In the Matter of)	Docket Nos. 50-275, 50-323
)	
PACIFIC GAS & ELECTRIC COMPANY)	
)	
(Diablo Canyon Power Plant, Units 1 and 2))	July 7, 2015

LIMITED APPEARANCE STATEMENT OF DR. VICTOR GILINSKY

OPINION OF COMMISSIONERS GILINSKY AND BRADFORD ON COMMISSION
REVIEW OF ALAB-644 (DIABLO CANYON SEISMIC PROCEEDING)

FIGURE NO. 4-23

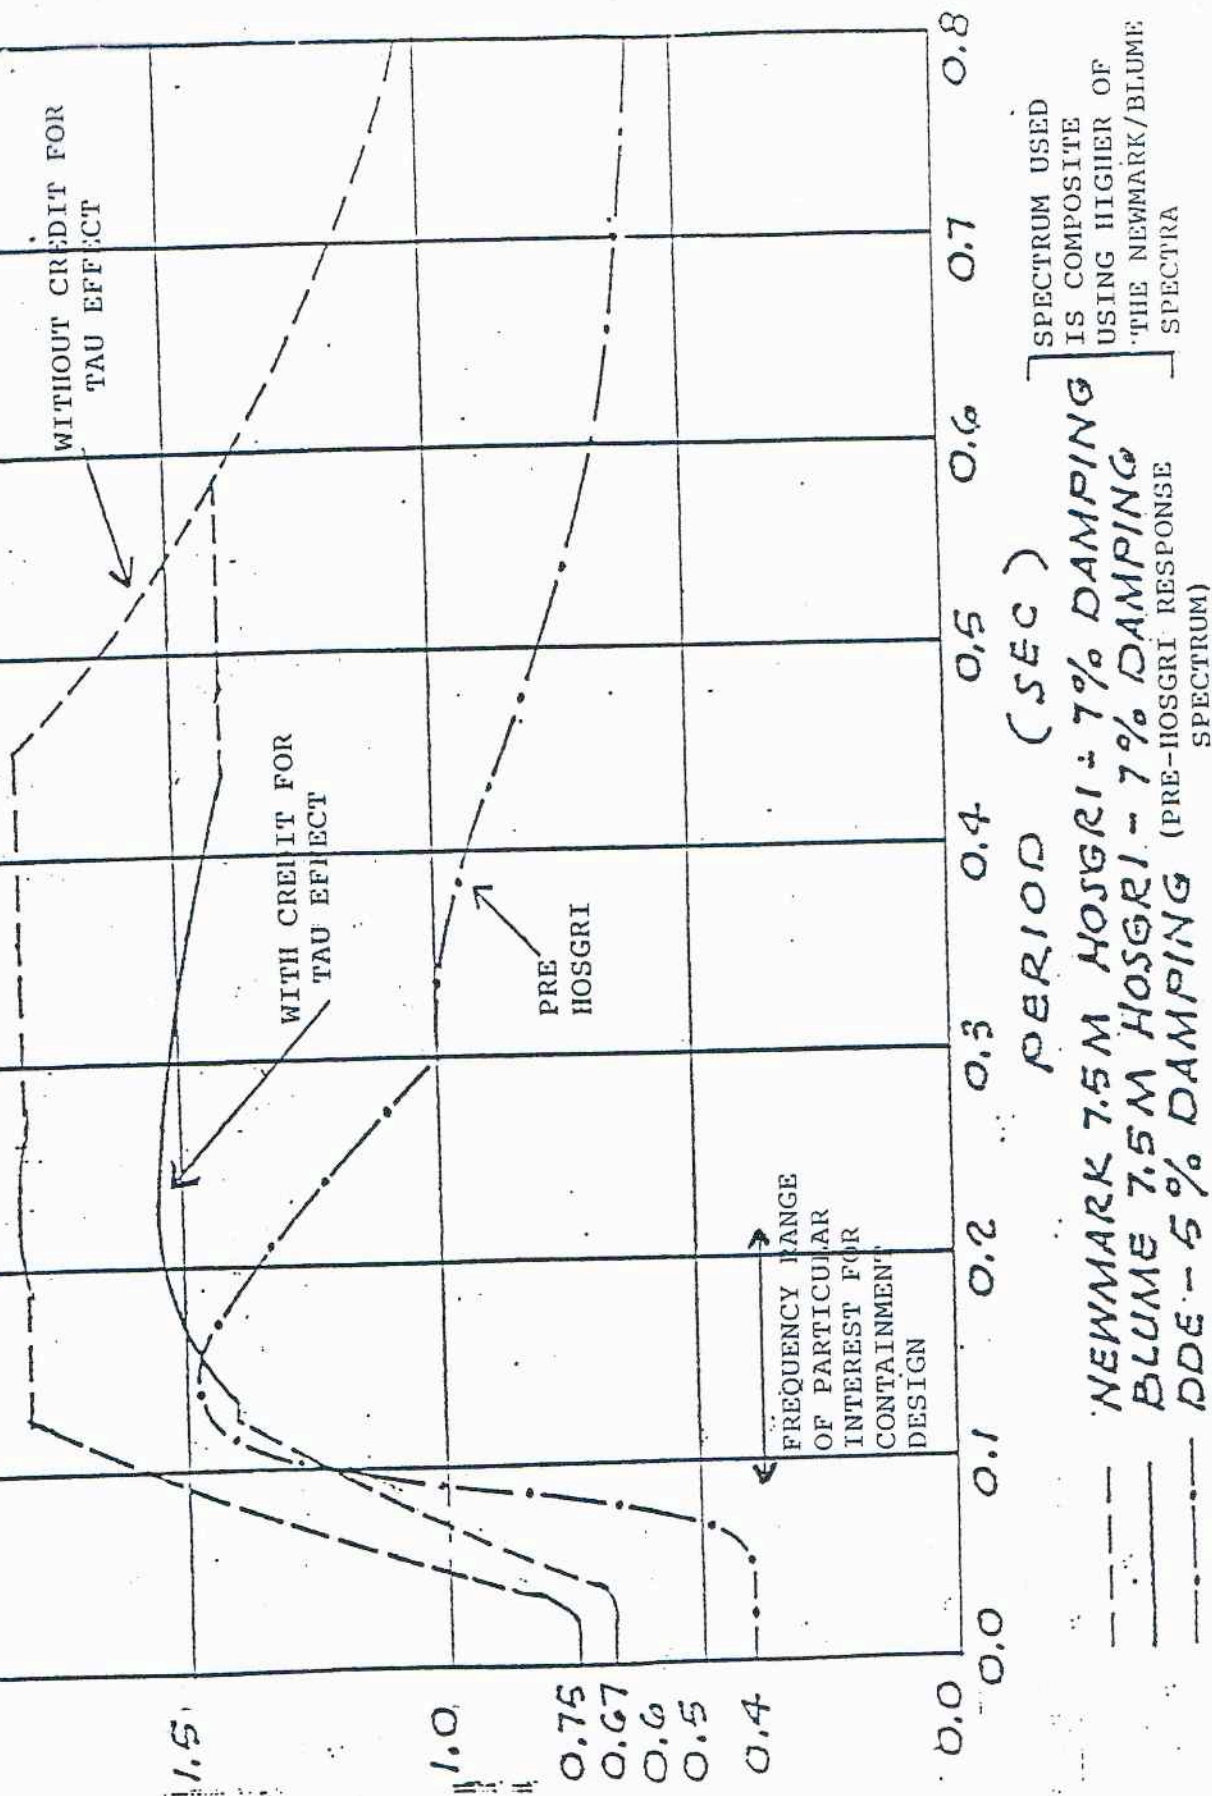
With the changes and adjustments permitted by the Board it turns out that the post-Hosgri seismic response spectrum does not in all respects represent a more severe seismic standard than the one used before the discovery of the Hosgri fault. As the accompanying diagram illustrates, in the frequency range between 5 and 10 hertz (cycles per second), a range of particular interest in the analysis of the containment building surrounding the reactor, the two response spectra are quite close.¹⁰ For part of this range, in fact, the old spectrum shows a higher response. In other words, for that part of the range the original design conditions were more demanding than the new ones imposed after the discovery of the Hosgri fault. This new

spectrum is the basis of the engineering reanalysis and ultimately determined the extent to which the containment was to be modified. Not surprisingly, in view of the above, only minor changes were required in this area.
